| 327.1 / 1604 Property Joint Venture Dove Creek Subdivision | |
| P.O.A.D.P. (Revised) | |

INFORMATION SHEET FOR
PRELIMINARY OVERALL AREA DEVELOPMENT PLAN
(P.O.A.D.P.)

Re: Dove Creek POADP
File #86-09-57-06

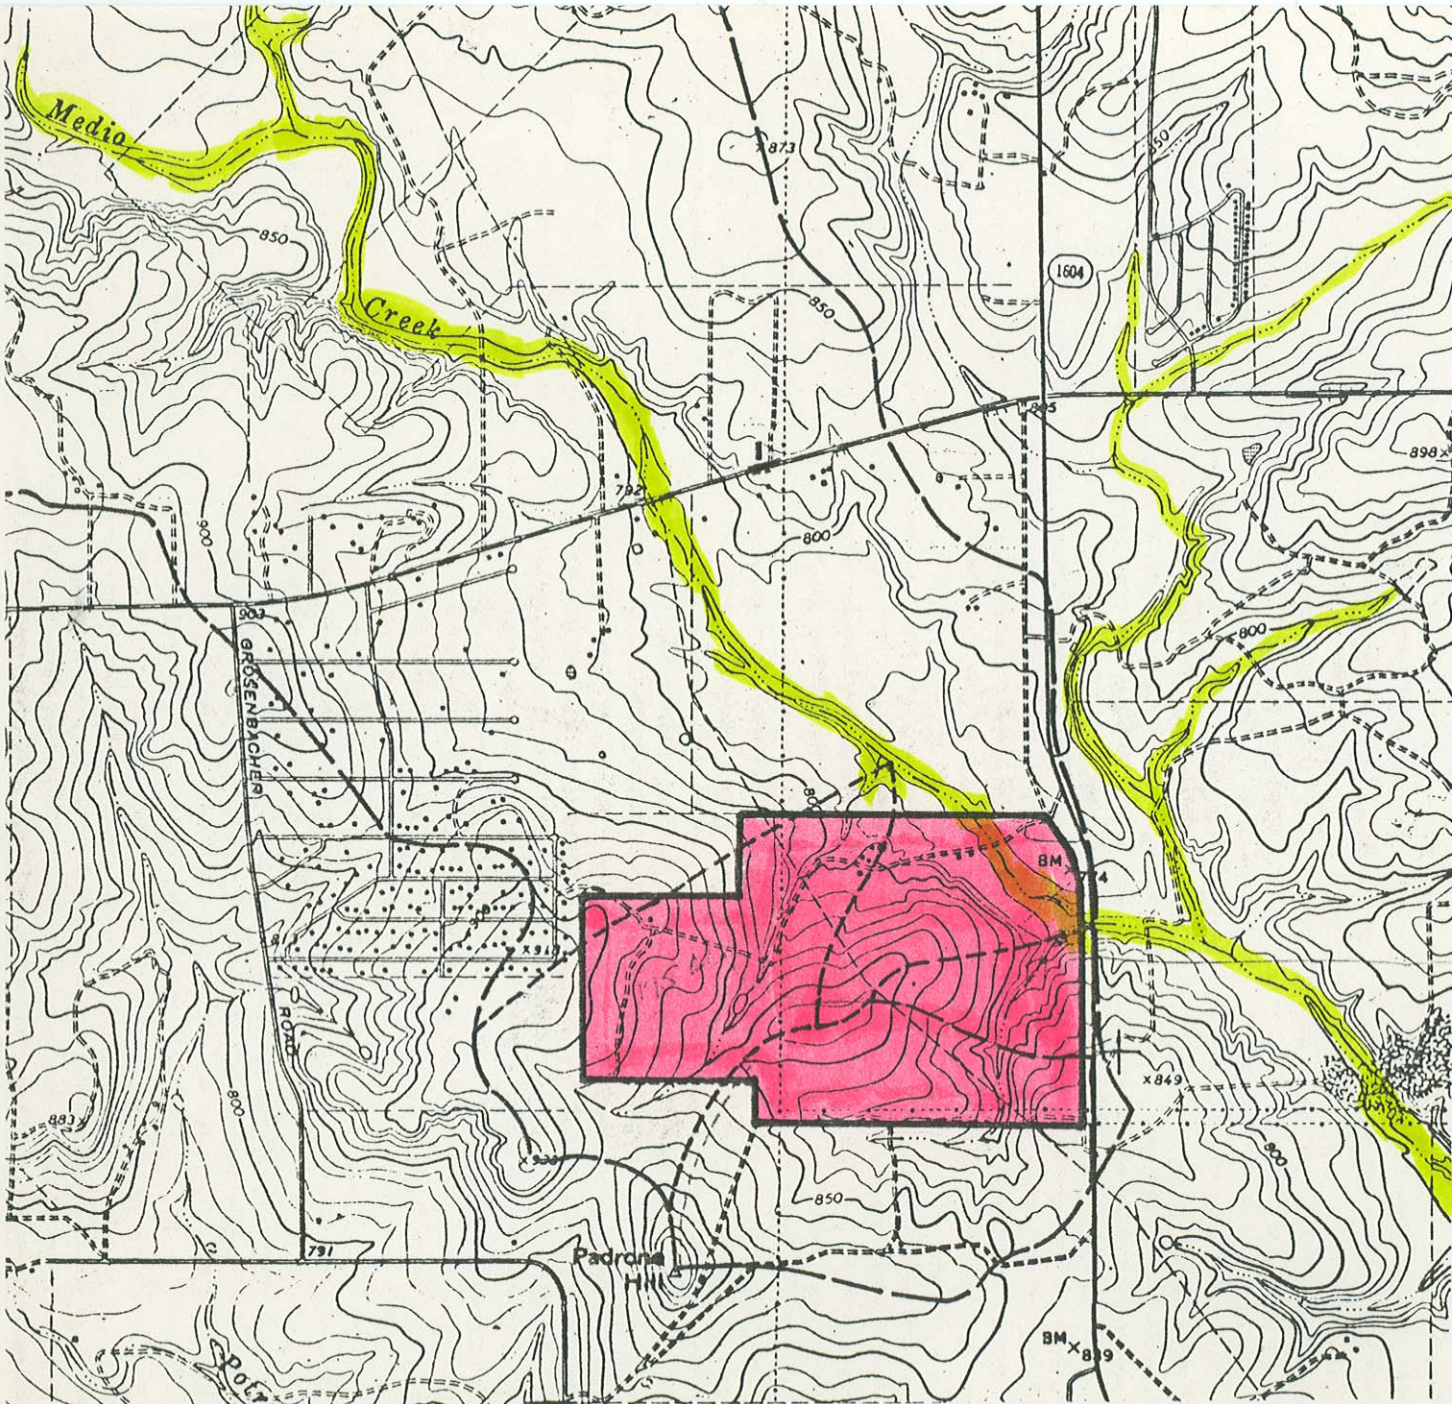
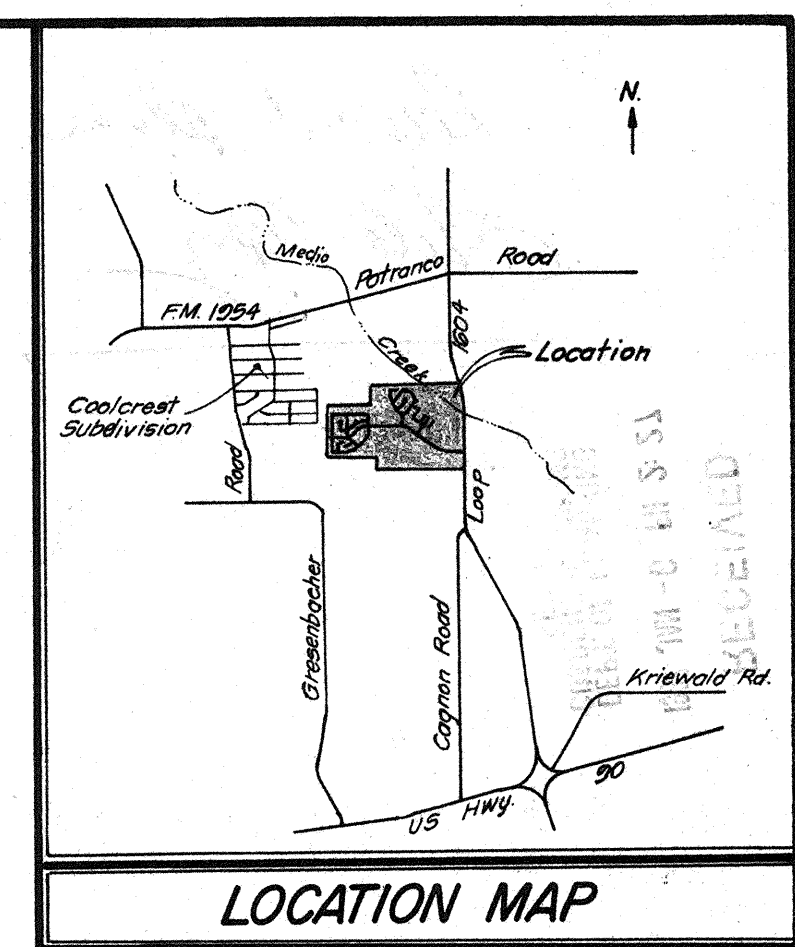
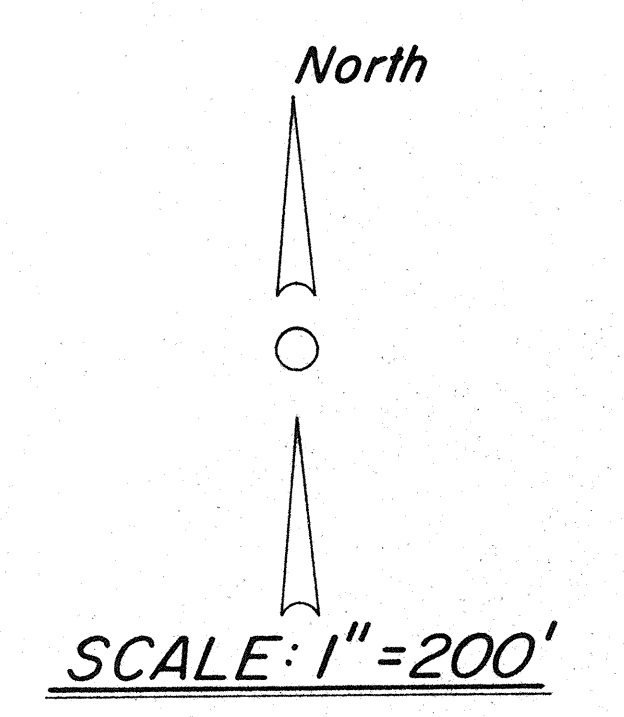
1. At its ultimate configuration, Loop 1604 will be a limited access freeway with one-way access roads. To facilitate access to the north from Dove Creek, the committee requests you consider a north-south collector street through the subdivision. The collector street might serve to separate the residential land uses from the non-residential.
2. Staff's policy is to require all stub streets to be collectors due to the unknown variables relating to the type of future development on adjacent tracts. Therefore, the committee requests you either delete the stub street to the 28.34 acre parcel on the west or upgrade it to a 60 foot right-of-way.
3. The committee also recommends you consider some type of buffering or separation between the duplex residential area and the proposed industrial park.

1. ADDED COLLECTOR STREET.
2. DELETED SUB STREET
3. ADDED BUFFER NOTE.
